DART AEROSPACE LTD		Work Order: 137021
Description: Crosstube Assembly (206L High Fwd)		Part Number: D206-667-143
Inspection Dwg: D206-667-143 Rev: C		Page 1 of 2

DESIGN	9	DART AEROSPACE LTD HAWKESBURY, ONTARIO, CANADA	
DRAWN	RF		
CHECKED	9	DRAWING NO. D206-667-143	REV. C
MFG. APPR.	9	SHEET 2 OF 4	
APPROVED	9	TITLE	SCALE
DE APPR.	9	CROSSTUBE ASS'Y (206L HIGH FWD)	NTS
DATE	08.11.06	COPYRIGHT © 2000 BY DART AEROSPACE LTD THIS DOCUMENT IS PRIVATE AND CONFIDENTIAL AND IS SUPPLIED ON THE EXPRESS CONDITION THAT IT IS NOT TO BE USED FOR ANY PURPOSE OR COMING OR COMMUNICATED TO ANY OTHER PERSON WITHOUT WRITTEN PERMISSION FROM DART AEROSPACE LTD.

DRAWING NO. D206-667-143	TITLE CROSSTUBE ASS'Y (206L HIGH FWD)	REV. C	DART AEROSPACE LTD ENGINEERING ORDER		D.E.O. NO. D206-667-143-C-1	SHEET NO. SHEET 1 OF 1	SCALE NTS
DRAWN <i>92</i>	CHECKED <i>ASS</i>	MFG. APPR. <i>MD</i>	APPROVED <i>MD</i>		DE APPR. <i>MD</i>		
DATE 11.07.15	DATE 11.07.20	DATE 11.07.21	DATE 11/07/21		DATE 11.07.21

DRAWING NO. D206-667-143	TITLE CROSSTUBE ASS'Y (206L HIGH FWD)	REV. C	DART AEROSPACE LTD ENGINEERING ORDER		D.E.O. NO. D206-667-143-C-2	SHEET NO. SHEET 1 OF 1	SCALE NTS
DRAWN AJS	CHECKED	MFG. APPR.	APPROVED	DE APPR

DETAIL P
BONDING STRAP INSTALLATION 2 PL

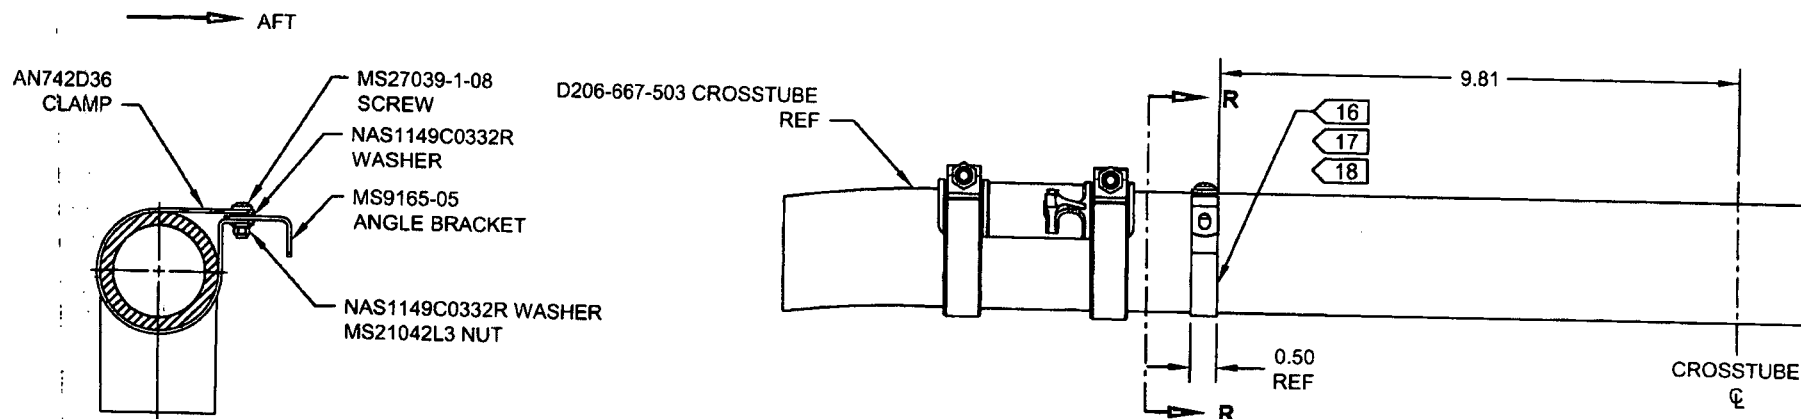
PURPOSE:

ADD ELECTRICAL GROUNDING STRAP

ITEM	QTY -143	PART NUMBER	DESCRIPTION
1	X	D206-667-143	CROSSTUBE ASSEMBLY (206L HIGH FWD)
10	2	AN742D36	CLAMP
11	2	MS9165-05	ANGLE BRACKET
12	2	MS21042L3	NUT (OR MS21042-3)
13	2	MS27039-1-08	SCREW
14	4	NAS1149C0332R	WASHER (OR AN960C10L)

- 16) MASK AREA UNDER CLAMP PRIOR TO PAINTING
- 17) SEAL EDGES WHERE AN742D36 CLAMP MEETS WITH THE CROSSTUBE USING SIKAFLEX-241/-291 OR MIL-S-8802 CLASS B2 OR PROSEAL 890 SEALANT
- 18) PERFORM RESISTANCE CHECK TO ENSURE MAX RESISTANCE IS 10 MILLIOHMS
